1.0 Executive Summary

The purpose of this report is to review and assess the conceptual layout and mode of construction for the on-airport segment of the proposed Automated People Mover (APM) at Fort Lauderdale-Hollywood International Airport. The report focuses on the following four areas of interest:

4.0 Review of Automated People Mover Conceptual Support Structure at Rental Car Facility (RAC)

FIGURE 16

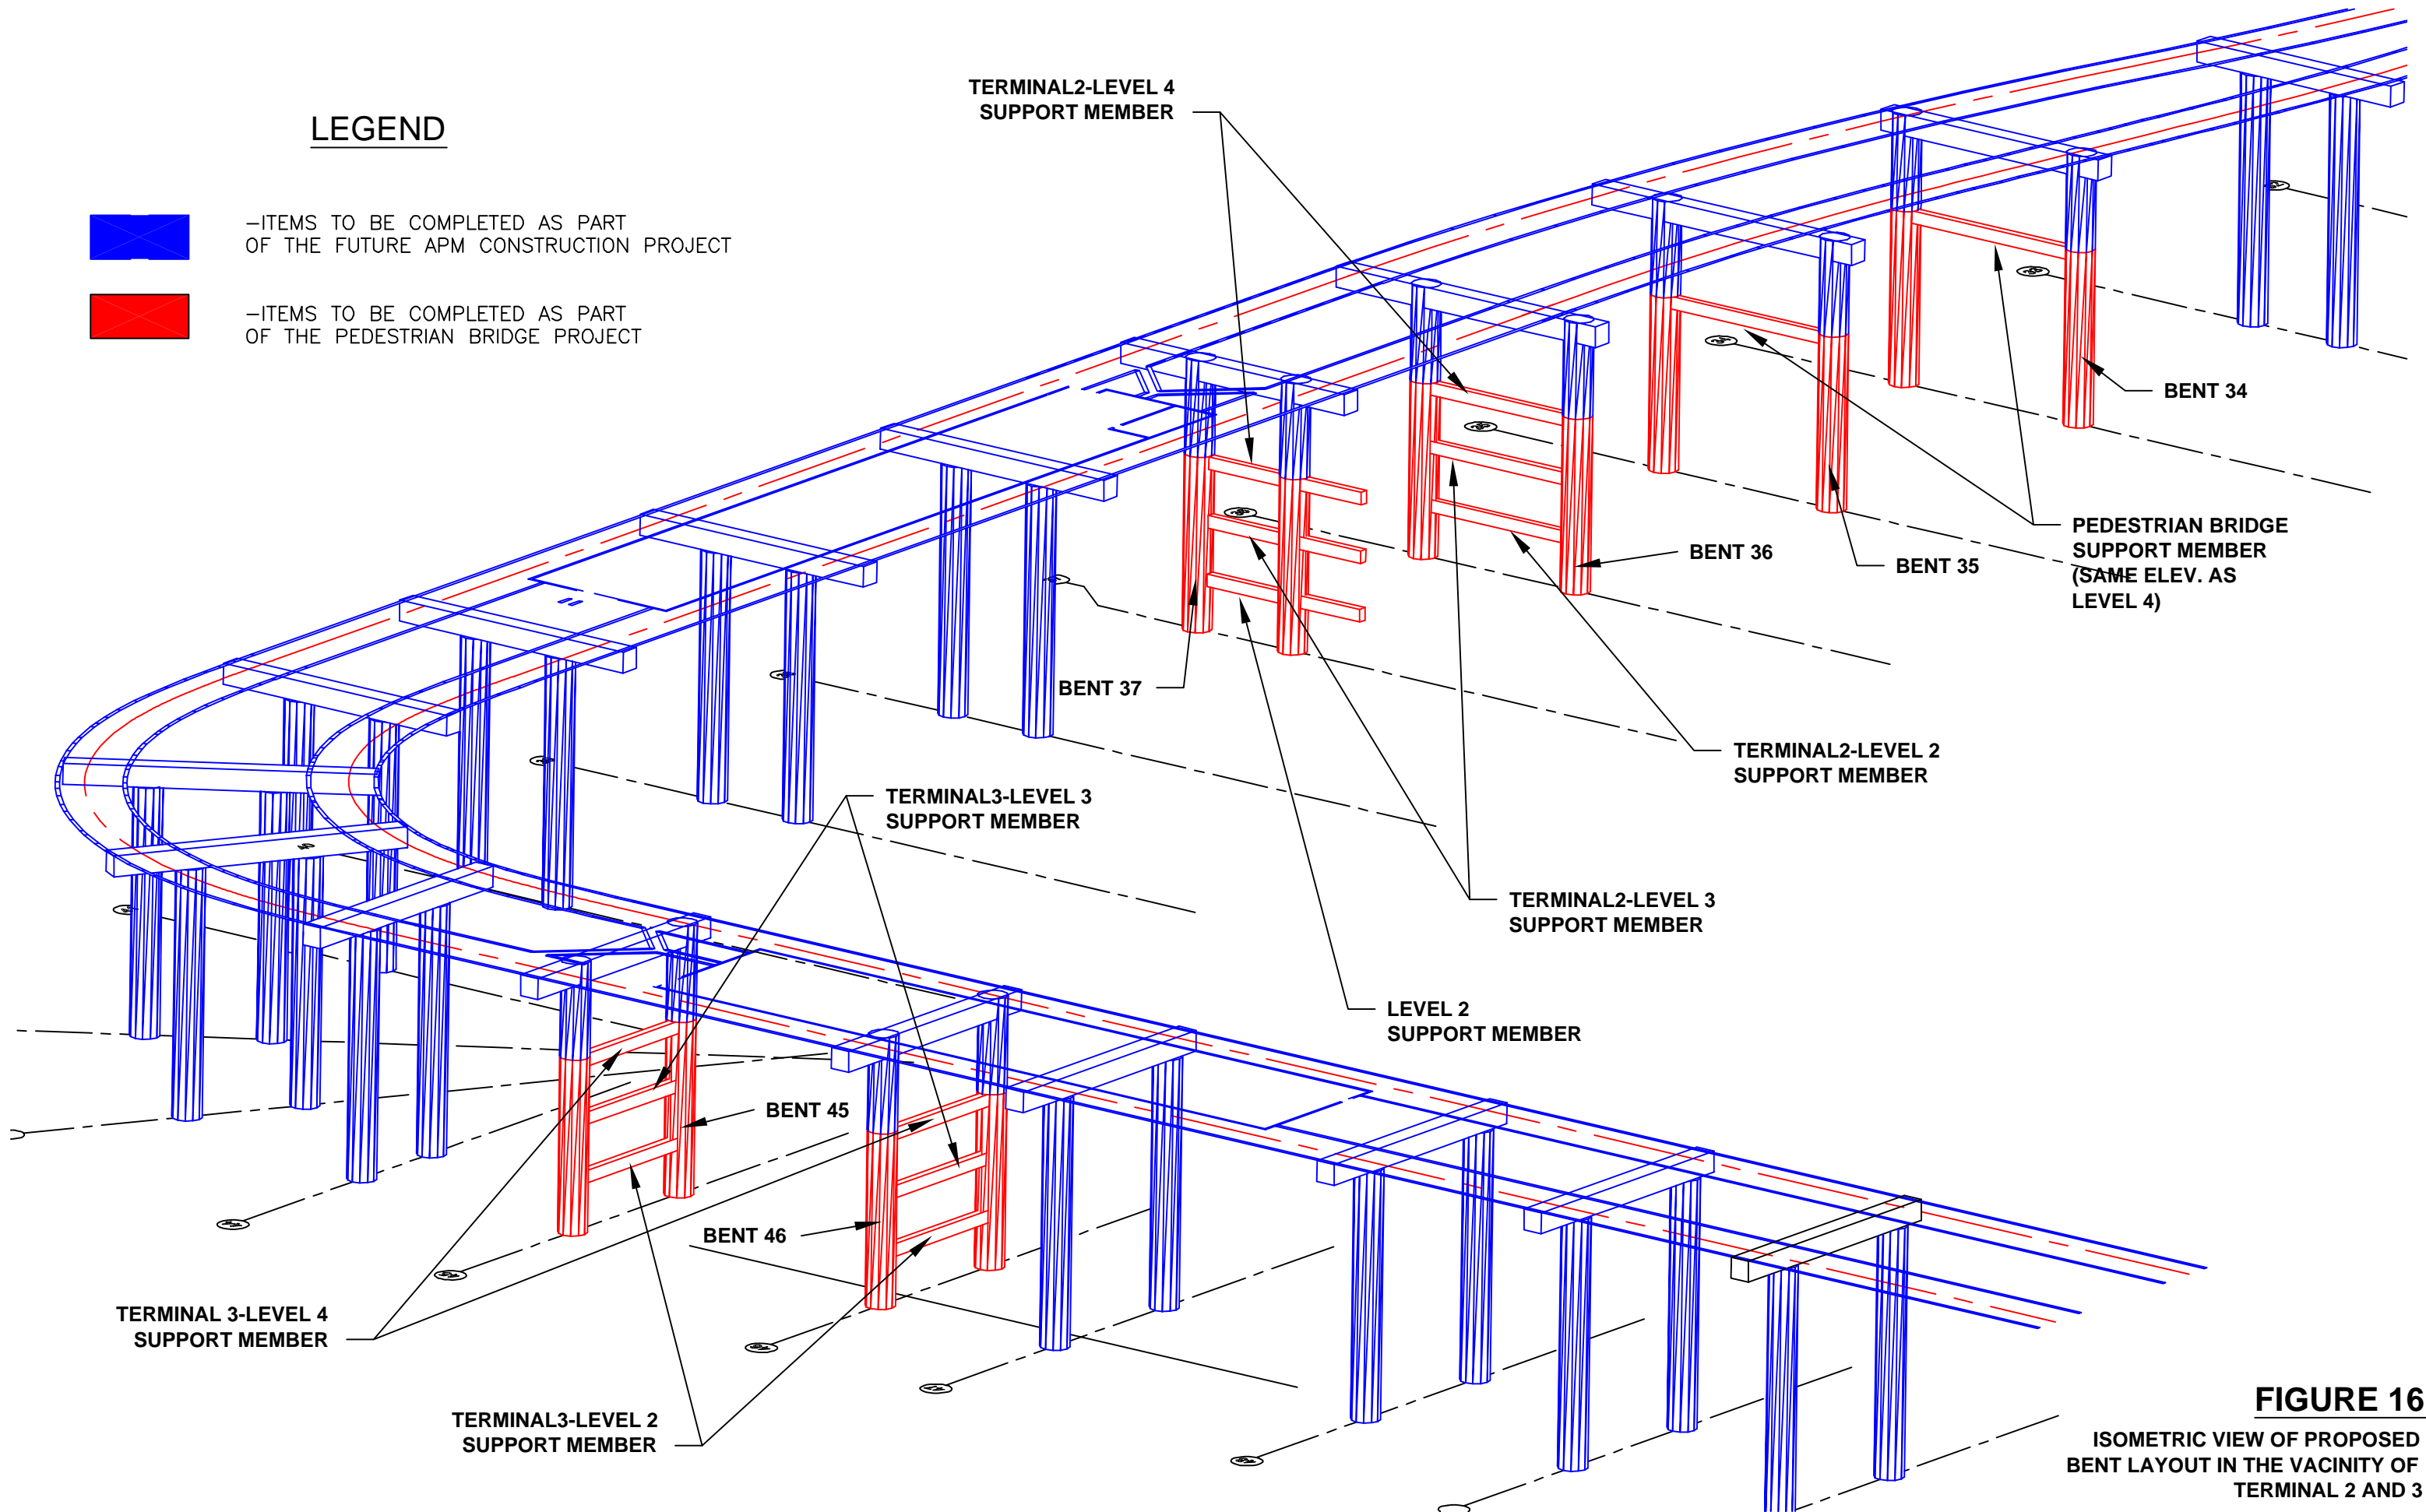
A more detailed description of the interface between the proposed APM support structure and the Pedestrian Bridge Projects at Terminal 2 and 3 follow in Section 5.0 and Section 6.0 of this report. An isometric representation of the bent layout in the area of these two terminals is shown on Figure 16.

It is recommended that the partial construction of bents 34 through 38 be incorporated into the Pedestrian Bridge Project (See Figure 16). This will assure that operational impacts to the Airport, which will have to reoccur during the Pedestrian Bridge Project, will not have to take place in the future when the APM is constructed. Another advantage is that the support structure for the APM can also be used to support the pedestrian bridges. Future construction of the APM will be made easier by extending the APM columns to just above the pedestrian bridges and providing mechanical couplers with threaded rebar in order to extend the APM columns in the future. Whether future APM bents are partly incorporated into the construction of the pedestrian bridges or they are built at a later date, it is important to observe the relationship between these bents and the existing and proposed structures.
